Memorial Drive Phase 3 Public Comments

deadline 7/21/2022

Re: Revised plans for the Memorial Drive Enhancement Program Phase III

Alternative 1: Formalize Existing Configuration

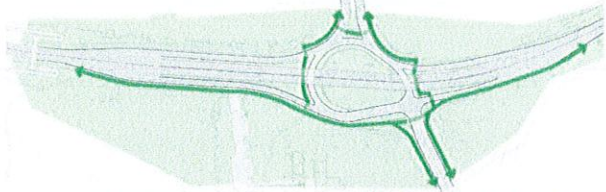
Suddenly in the FRAUD which is too common in the DCR, the BU Bridge Rotary extends beyond the eastern extreme of the Wild Area. THE WILD AREA IS THE NARROW AREA TO THE RIGHT. THAT IS FRAUD.

Compare the slope's top edge to the outline of "BU BRIDGE CIRCLE" in the three slides. The outline in the slides extends to the right of this plan.

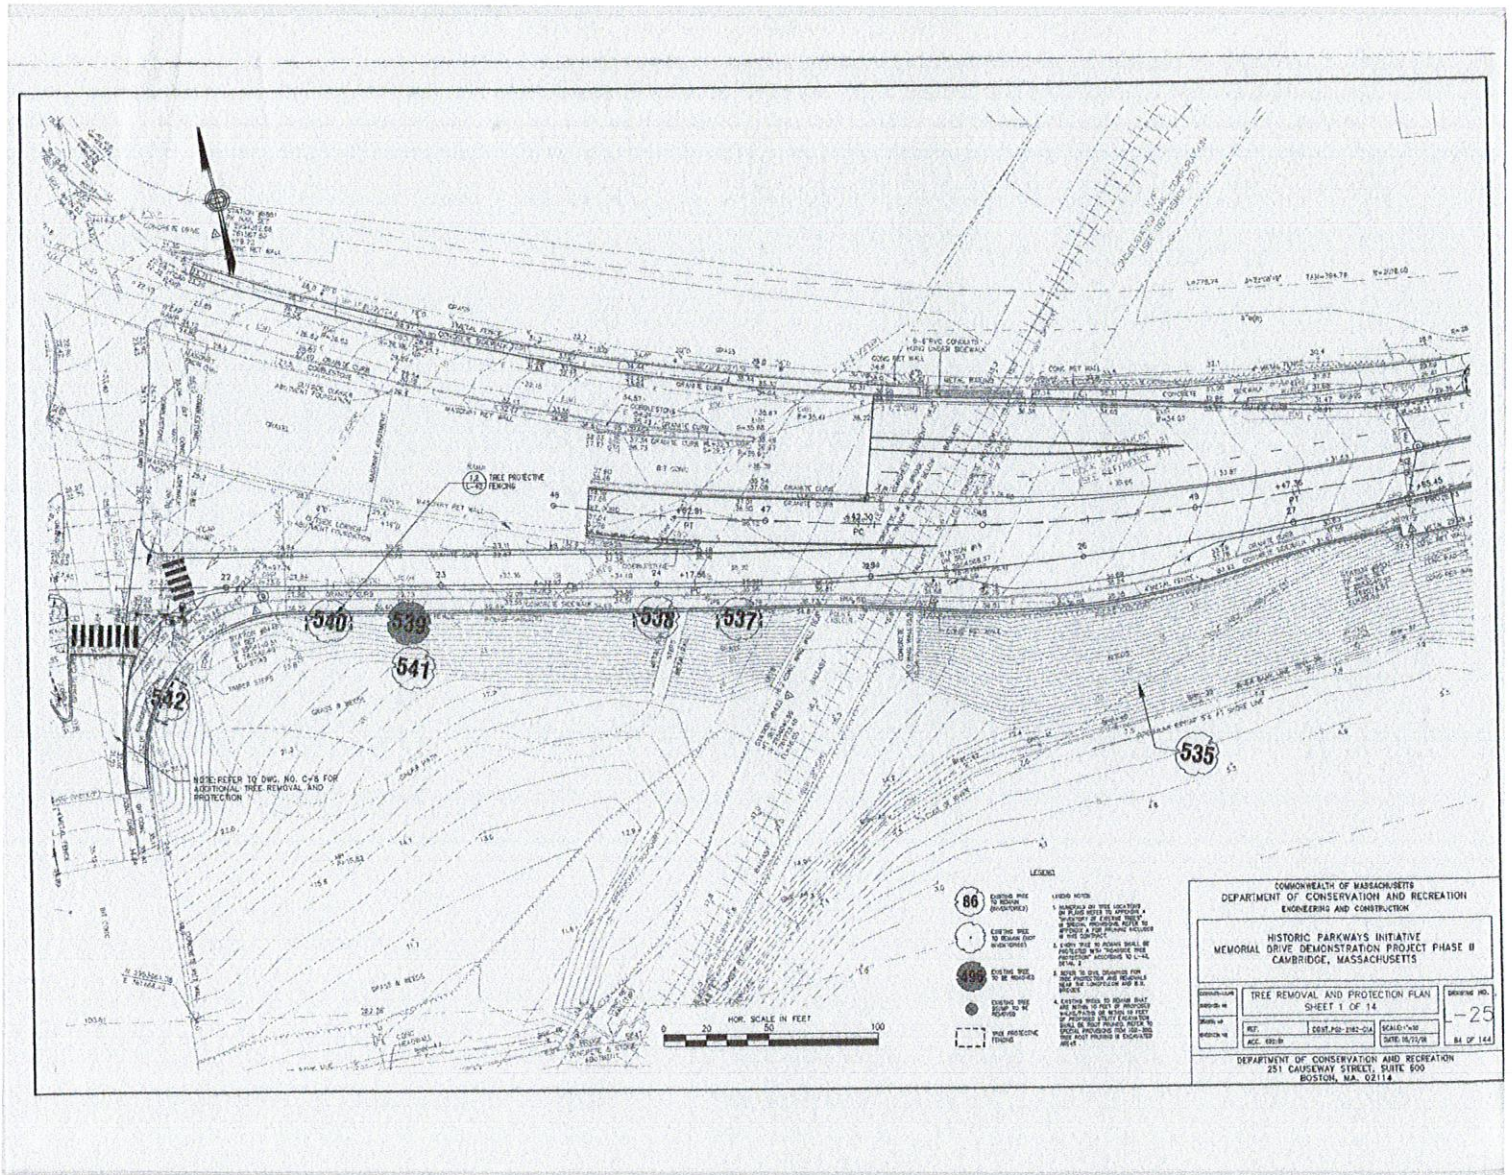
The destruction plans show EXACTLY ONE TREE NOT DESTROYED, and lie through omission of the thick woods. IN DIRECT VIOLATION OF THE EXPLANATION ON THE BOTTOM RIGHT.

The DCR plans whose validity was extended by the legislature long after they became outdated included destruction of the Wild Area with the usual lying. THE PLANS DID NOT SHOW ANY OF THE MORE THAN 100 TREES IN THE WILD AREA. They show exactly one tree NOT DESTROYED:
